**ITEM FOR ENVIRONMENTAL BOARD AGENDA**

**NAME & NUMBER OF PROJECT:** Judge's Overlook - SP-2011-0051D

**SUBJECT:** Judge's Overlook (SP-2011-0051D)  
6916 FM 2244 (Bee Caves) Rd.

Variance Requests: Variance from LDC 25-8-341 and 342 to allow cut not to exceed 8 feet and fill not to exceed 8 feet for construction of a driveway. Variance from LDC 25-8-454(D)(1)(a) to allow the development to construct up to 21% of impervious cover on the site.

PROPOSED CUT AND FILL EXHIBIT

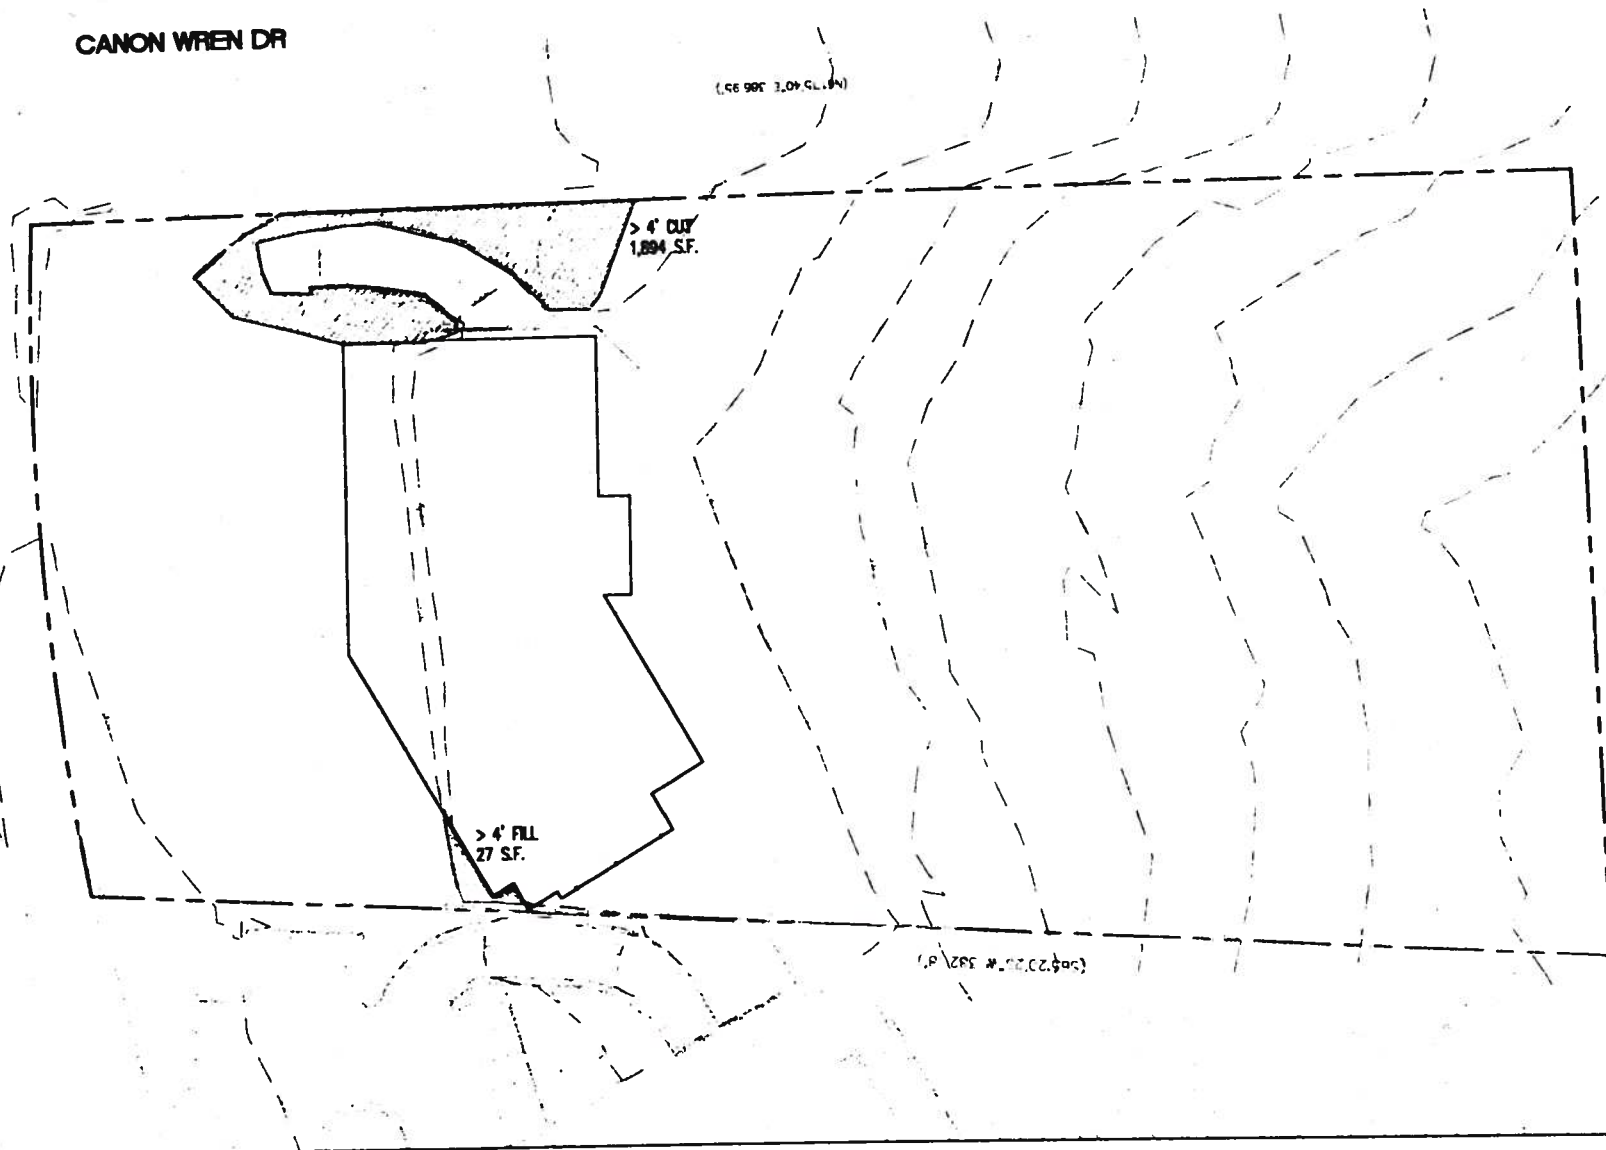
*Yes. The development is not based on a condition caused by the method chosen by the applicant to develop the property. The site's terrain slopes to such an extent that drive aisle must be recessed into the ground over 4 feet in places to provide the proper driveway slope for the safe passage of vehicles. In addition, TXDOT forbids the access of this property from FM 2244 and therefore the site must be accessed from Canon Wren.*

*Yes. The development is not based on a condition caused by the method chosen by the applicant to develop the property. The site's terrain slopes to such an extent that a small portion, about 27 square feet, must be filled over 4 feet between the parking area and the building for pedestrian safety.*

Along the southeast corner of the proposed building, an area of approximately 27 square feet will be filled more than 4 feet. Filling this area is necessary for pedestrian safety. Along the western side of the proposed building, an area of approximately 1,894 square feet (which represents less than 3% of the site) will require a cut greater than 4 feet in order to access the upper portion of the site from the driveway on Canon Wren. TxDOT requires that the site is accessed from Canon Wren.

1. Areas of cut and fill will be revegetated with no greater than a 3:1 slope or be structurally contained.
2. Landscaping will be provided to ensure all parking areas are buffered from Bee Caves Road and Canon Wren Drive.
3. At least one tree will be planted within 50 feet of each uncovered parking space.
4. Implementation of an Integrated Pest Management (IPM) plan.
5. A water quality biofiltration pond will be constructed to capture and treat all new impervious cover proposed in this site plan.
